Lake County Department of Public Works
West Pump Station Force Main Replacement
Bid #25223
Project #2022.116
Addendum#3 June 6, 2025

VERNON HILLS FORCE MAIN REPLACEMENT
LAKE COUNTY DEPARTMENT OF PUBLIC WORKS
LAKE COUNTY, ILLINOIS

EXIST. COND./DEMO. (STA 10+50 TO 19+00)

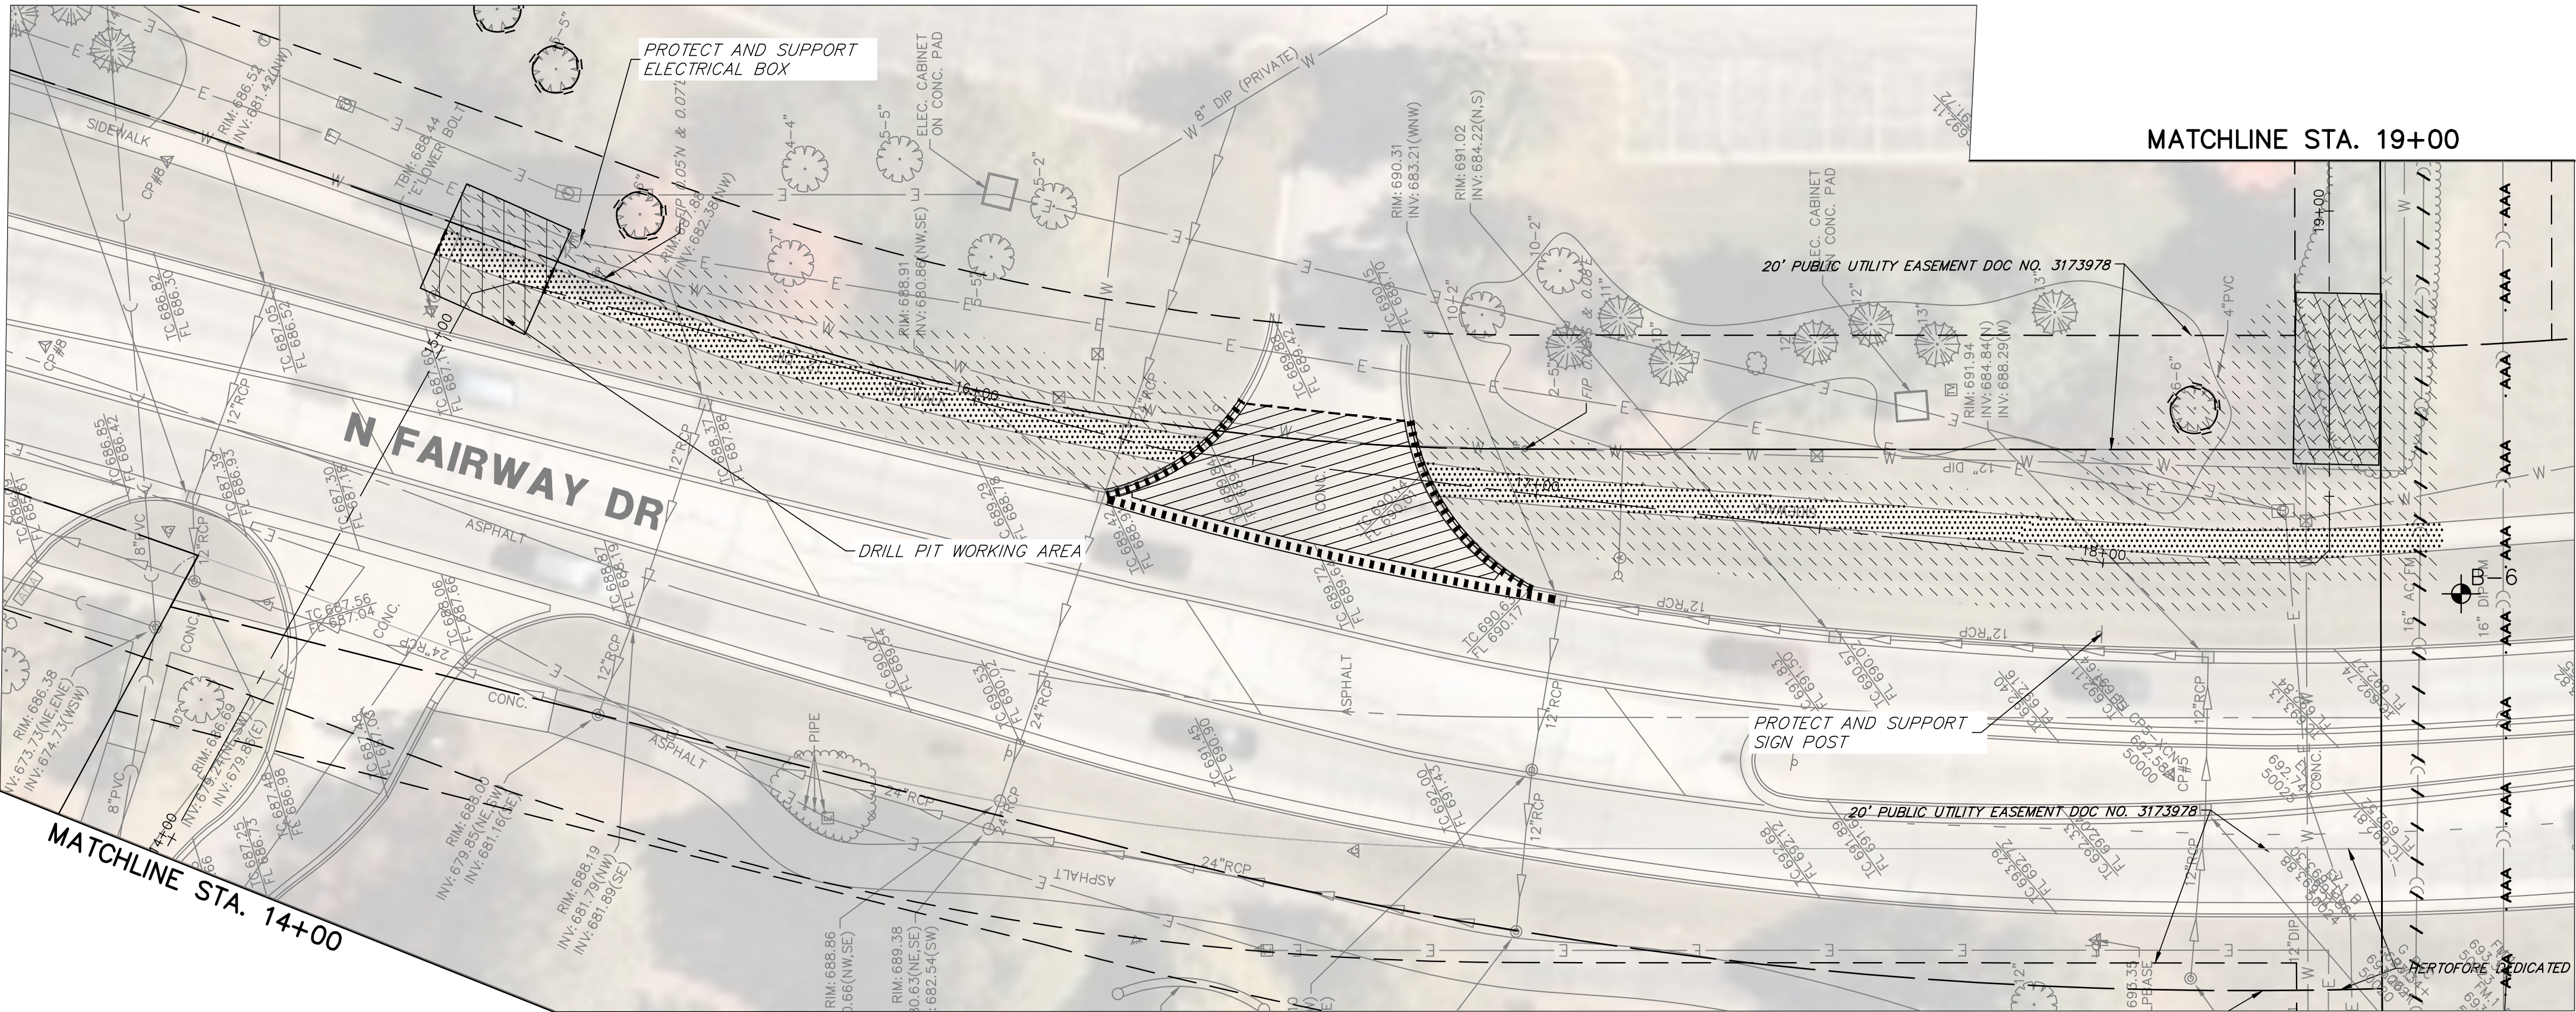
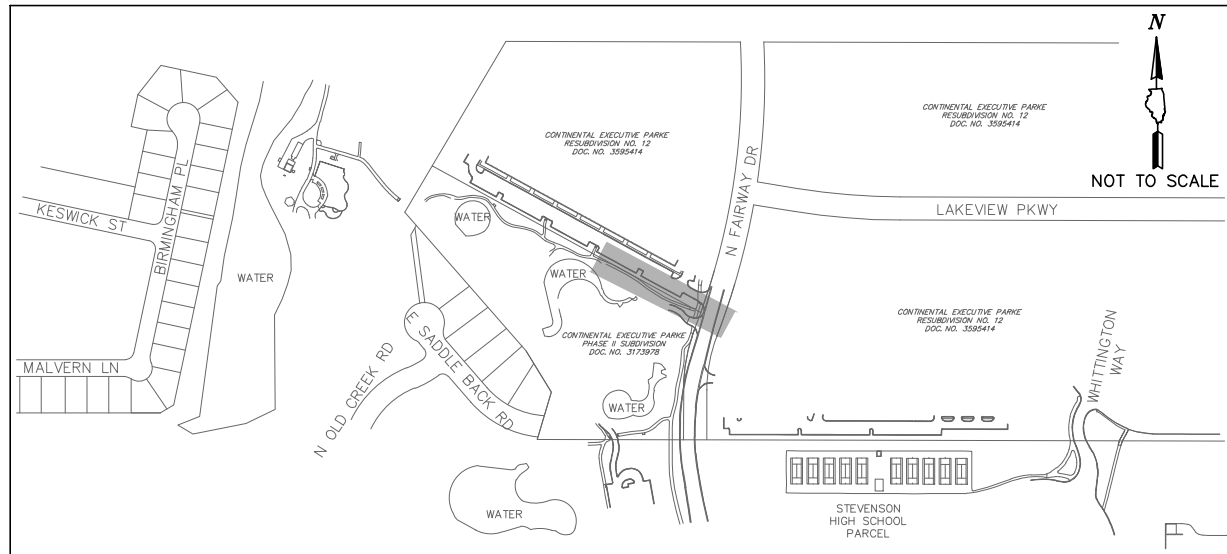
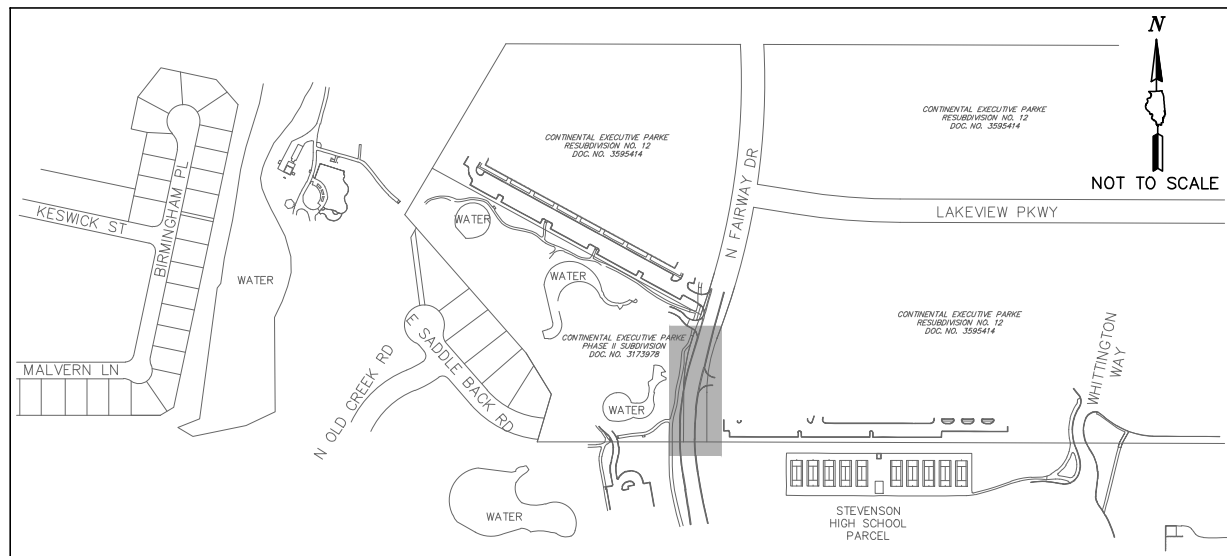
1. Sheets 7 and 8 of the Civil Engineering plan set have been revised to provide information regarding the coir log installation. The Contract Documents shall be amended to replace the existing Sheets 7 and 8 with the revised versions.
2. Sheets 25 and 26 of the Civil Engineering plan set have been revised to include additional details for coir log installation, and silt fence splicing. The Contract Documents shall be amended to replace the existing Sheets 25 and 26 with the revised versions.

Construction Requirements: Coir Logs as shown on the drawings and plan details shall be installed prior to mobilizing equipment to install the proposed sanitary sewer. Additional coir logs as needed based on the contractors operations shall be installed to prevent sediment from leaving the construction areas as determined necessary by the County.
